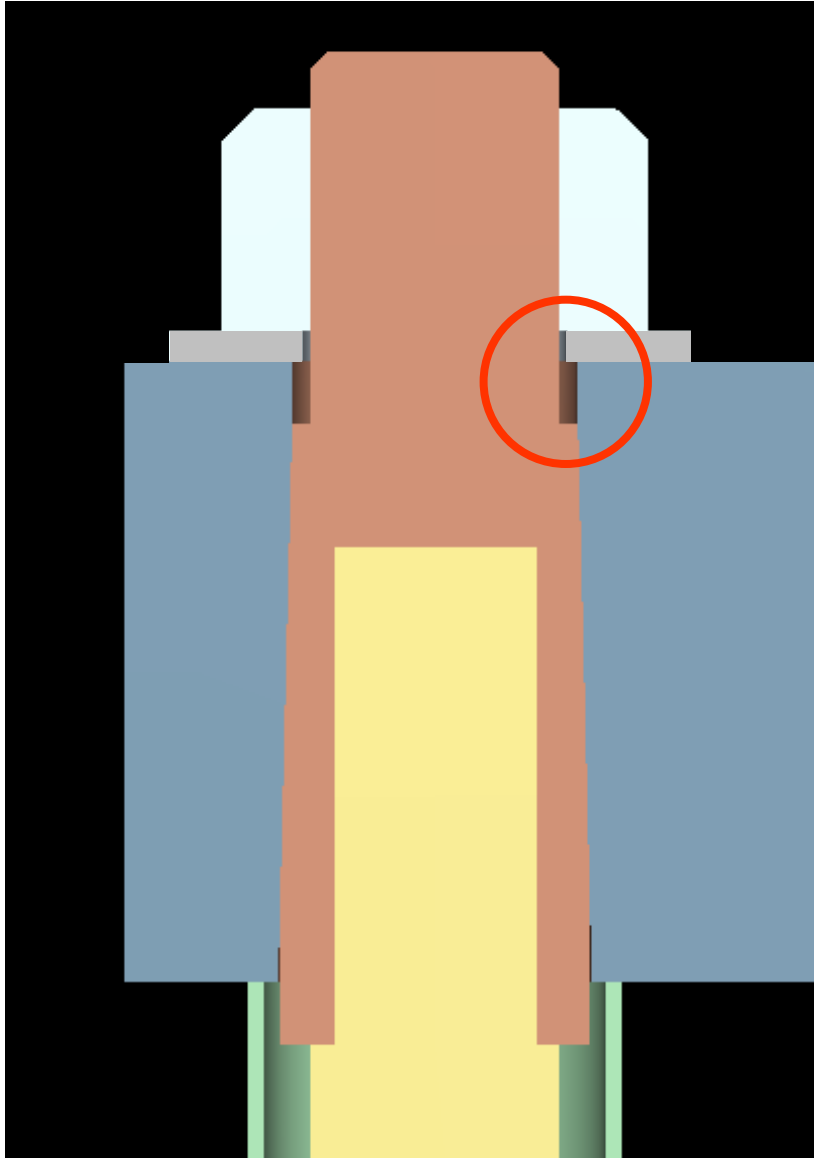
Early cartoon done in July of '04 showing a longer shoulder that would not interfere with the washer(s) (simple schematic)

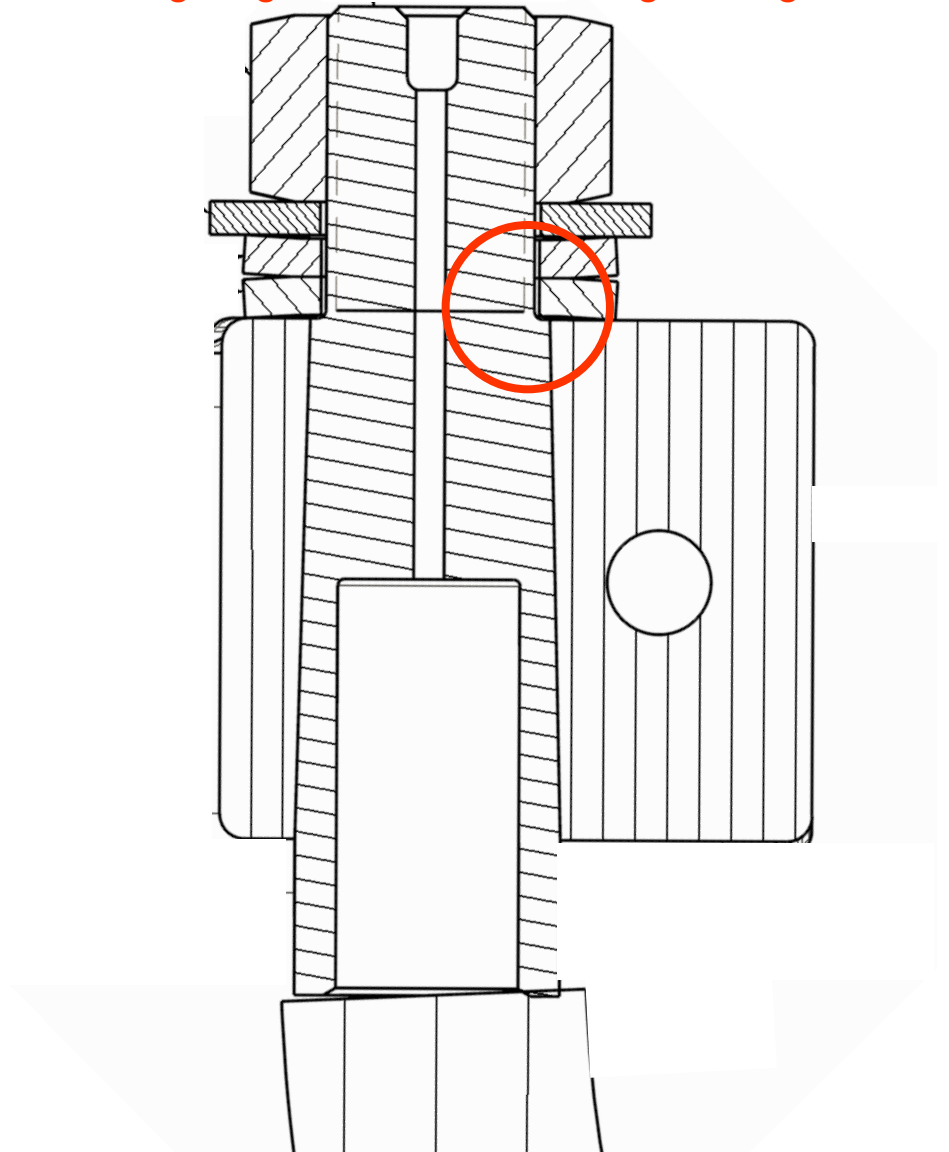
It's no mystery as to why the connector may not get fully seated in the jumper or lug sockets. The nut tightens the bellville washers against the connector shoulder, but not necessarily the socket, giving a false sense of "tightening".
